FRANKLIN RD.
ASBUILT
11-14-2017
BILLY THOMAS
CIP-1

PLAN & PROFILE

FRANKLIN ROAD
WATERLINE RELOCATION
PREPARED FOR
WESTERN VIRGINIA WATER AUTHORITY
SITUATED IN
THE CITY OF ROANOKE, VIRGINIA

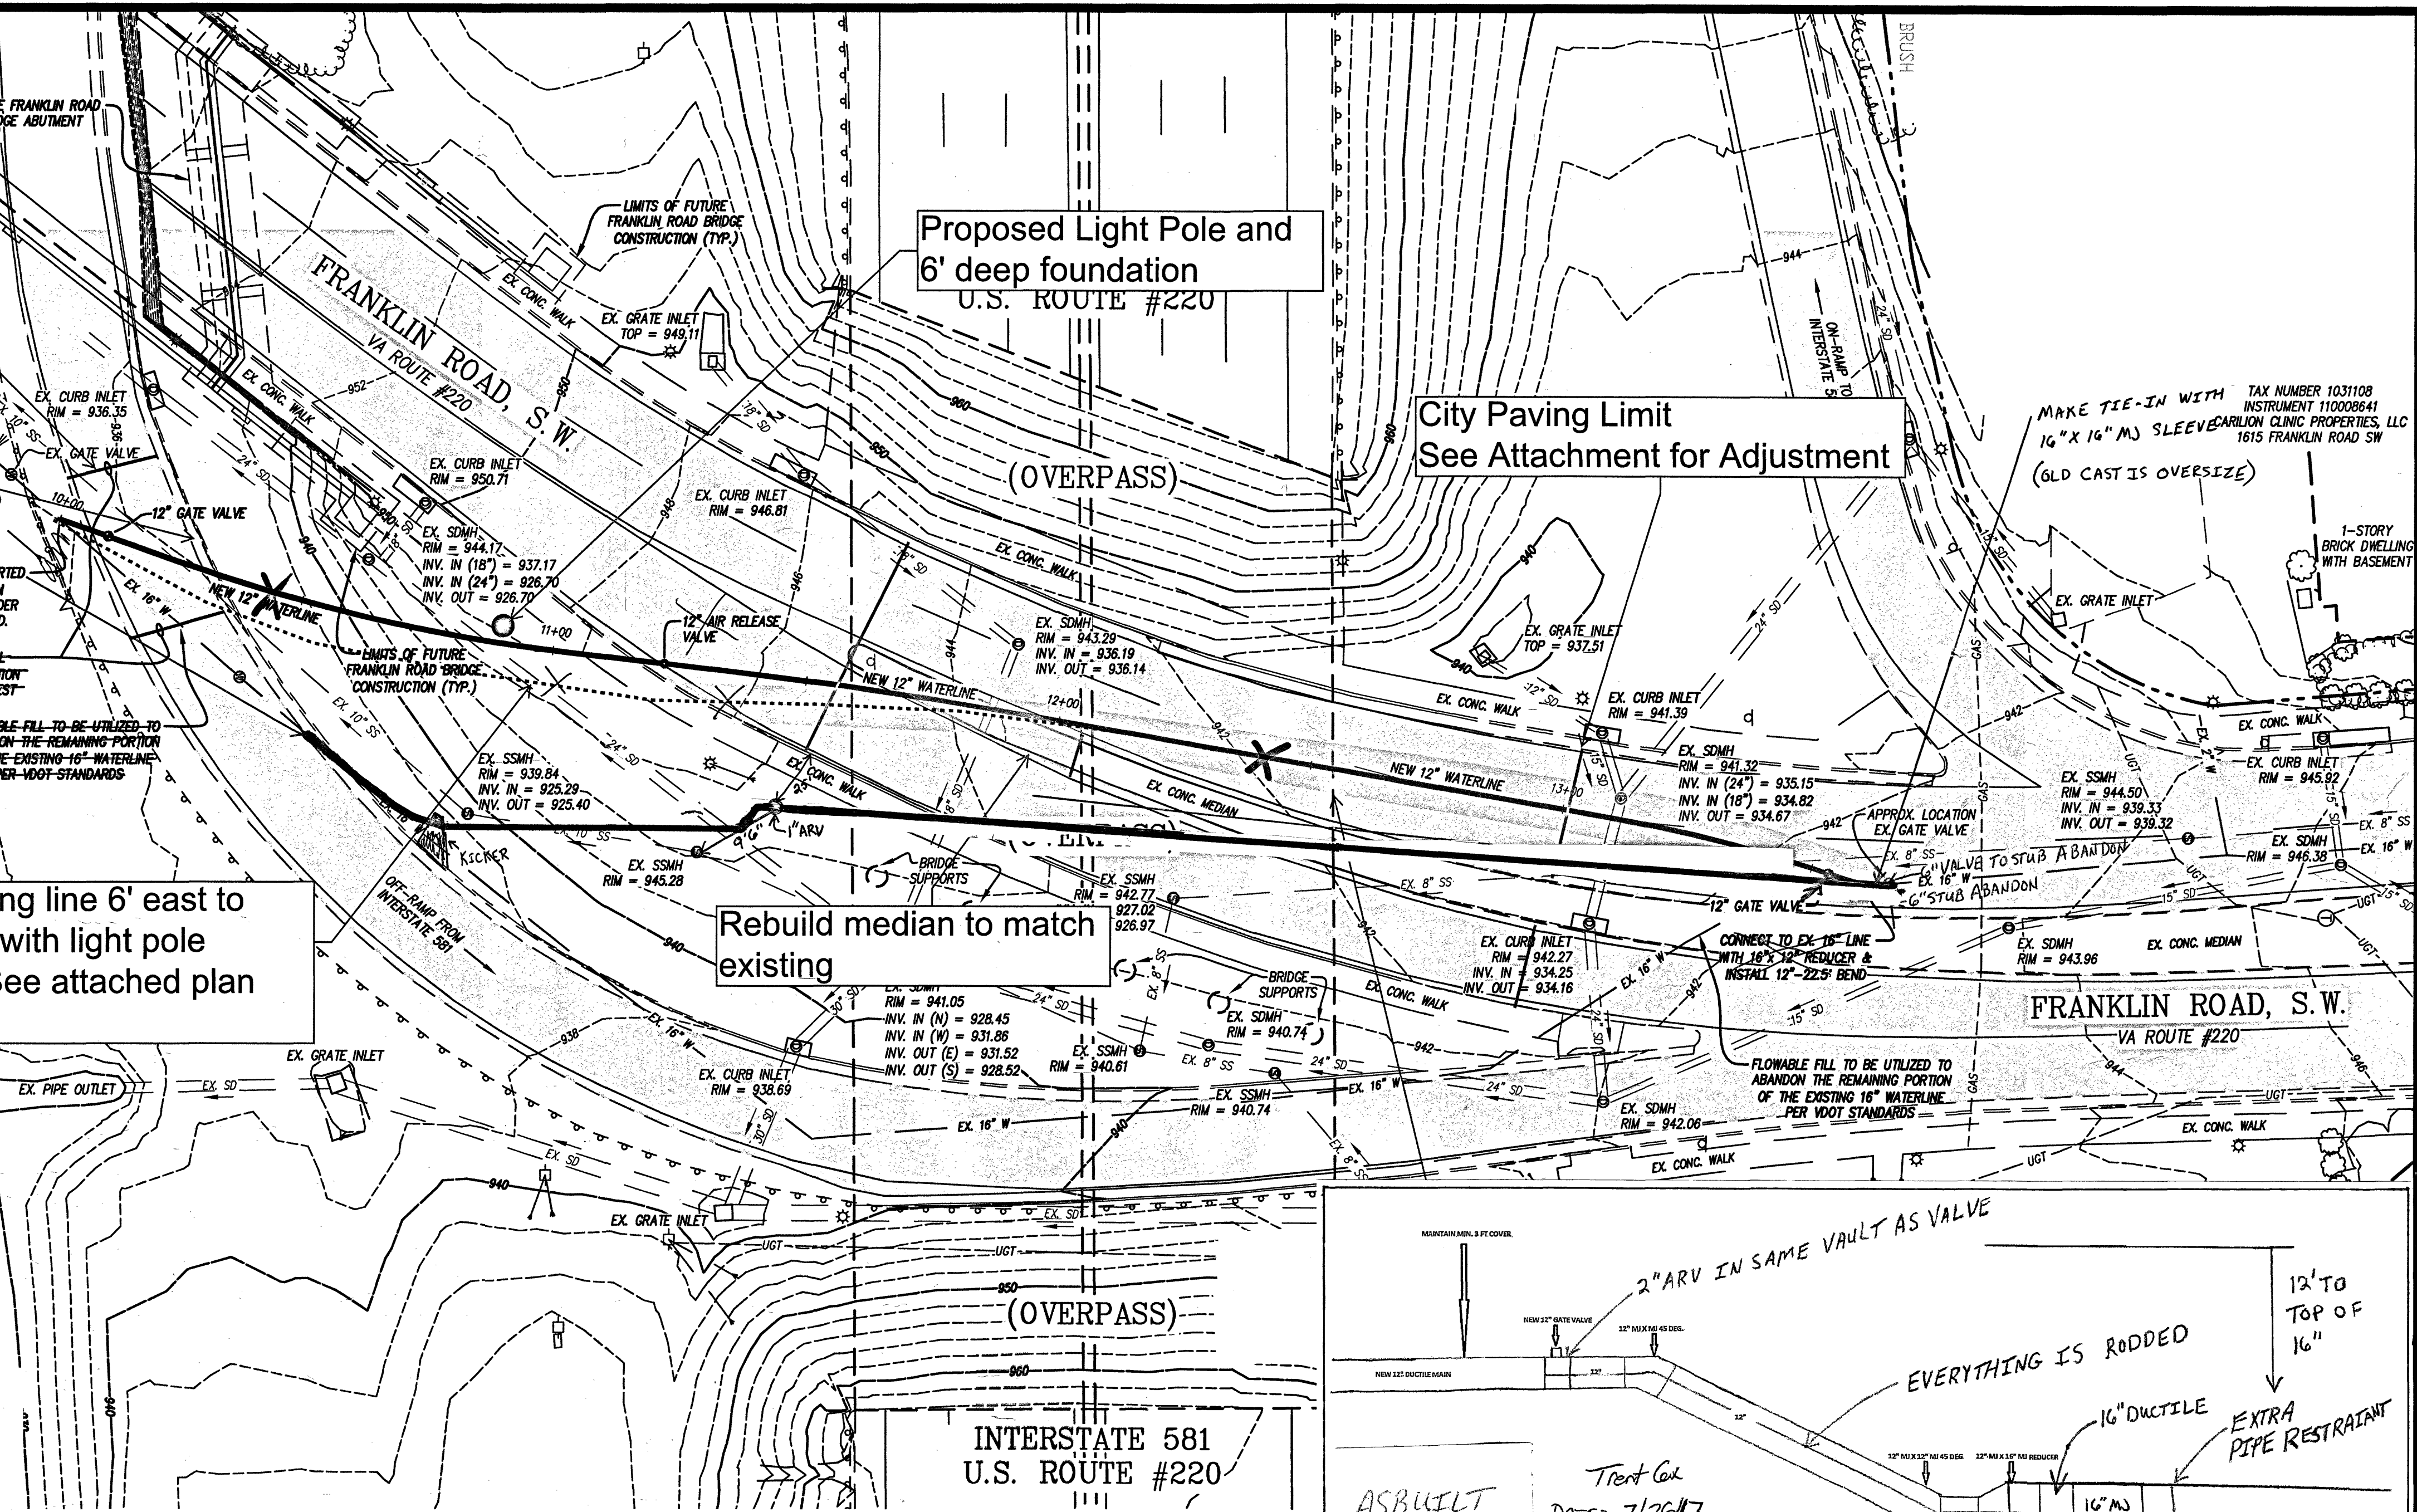
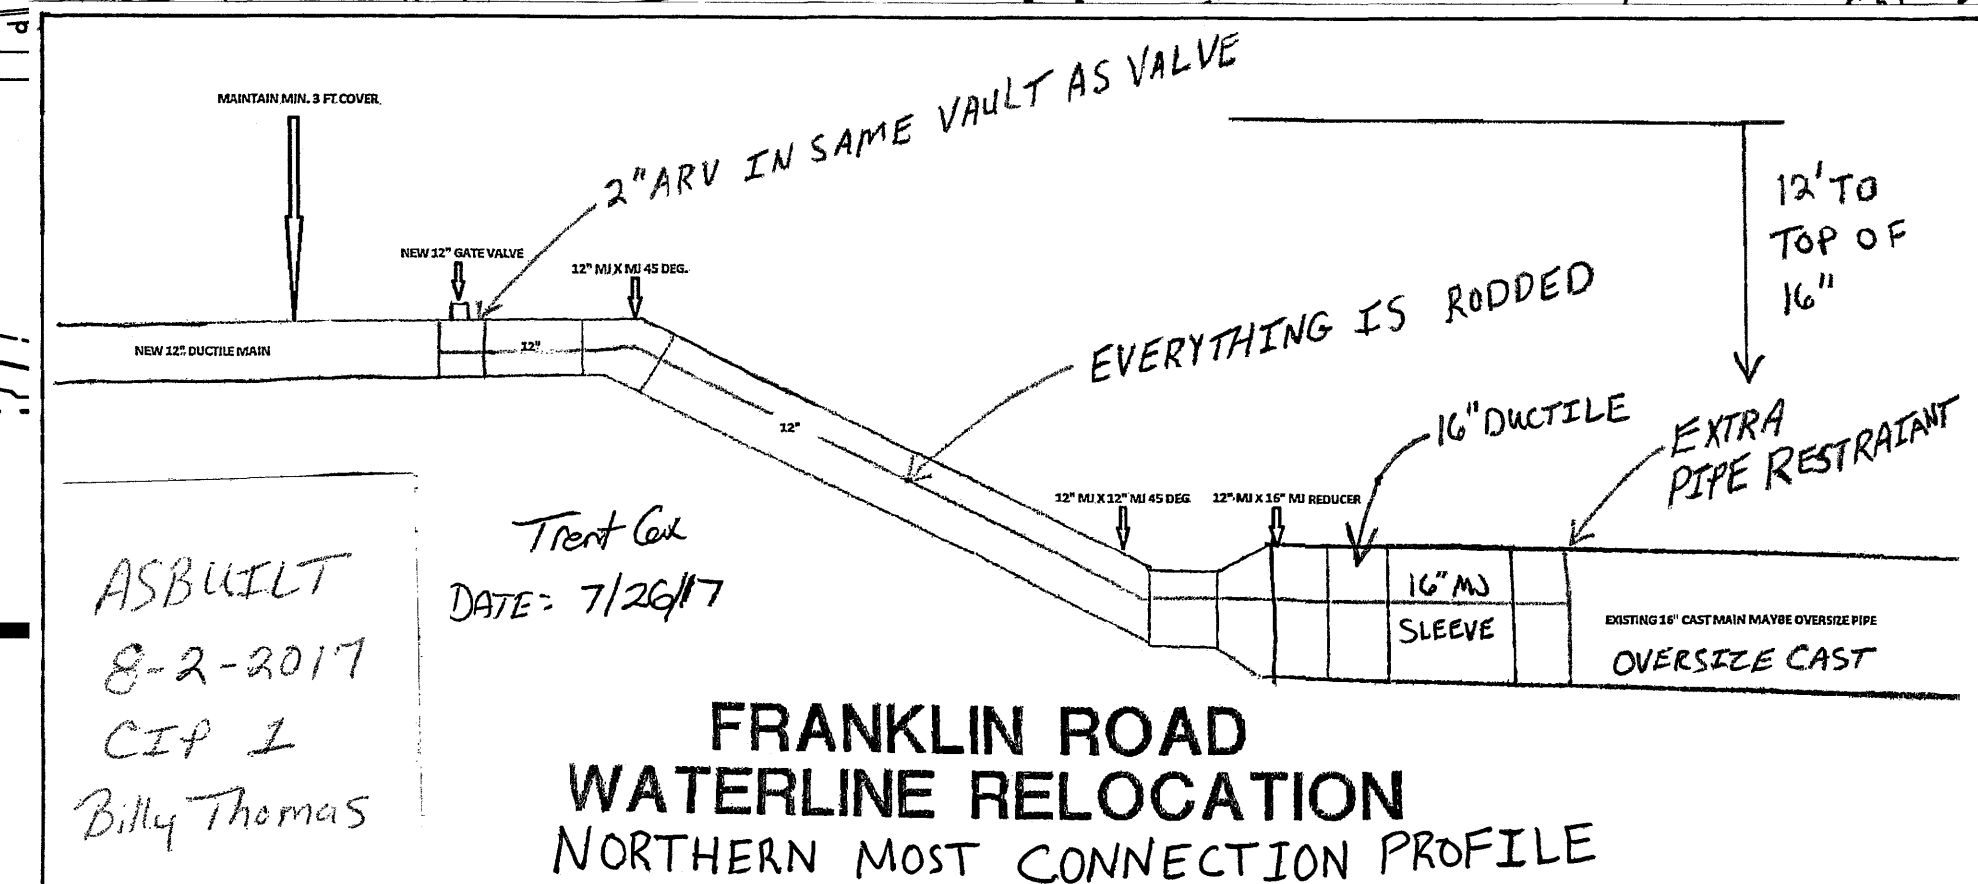
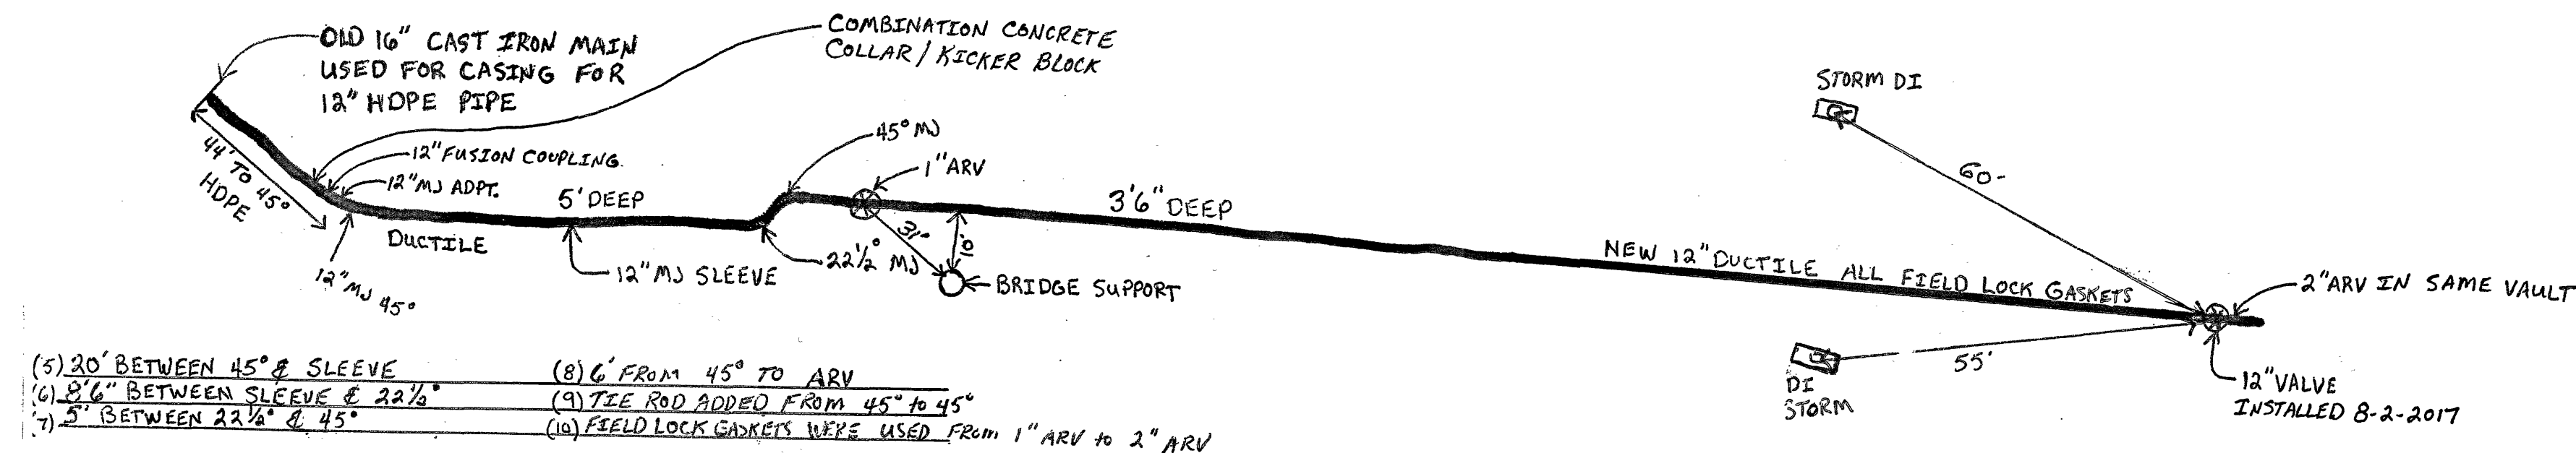
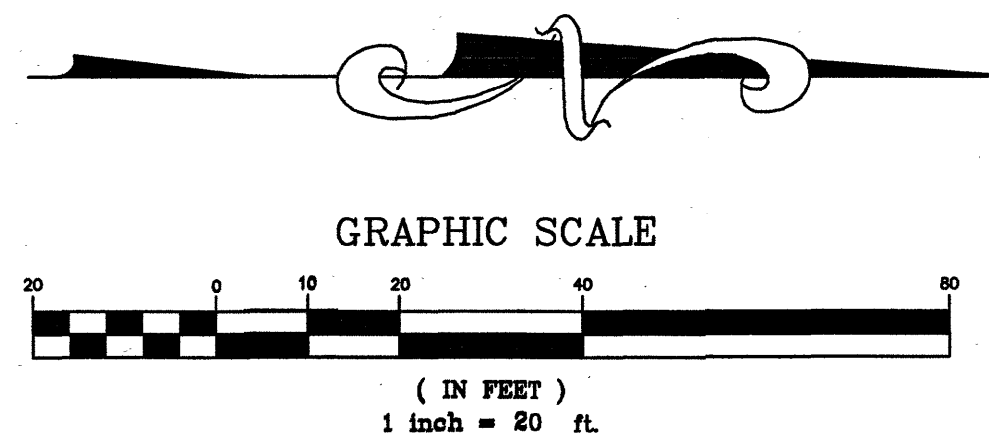
Replace curb and
gutter if disturbed

MAKE TIE-IN WITH
16" X 16" M3 SLEEVE
(OLD CAST IS OVERSIZE)

Suggest shifting line 6' east to
avoid conflict with light pole
foundation. See attached plan
sheet E-103

Rebuild median to match
existing

- (1) 225' FROM NEW 12" VALVE TO 1" ARV
- (2) 10 YARDS OF CONCRETE BEHIND 45° (KICKER & COLLAR ARE 4" THICK)
- (3) TRACE SAFE TRACER WIRE USED FROM 1" ARV THROUGH 16" CASING TO OTHER SIDE OF NS RR
- (4) TRACER WIRE WAS ALSO CONNECTED TO 16" CASING
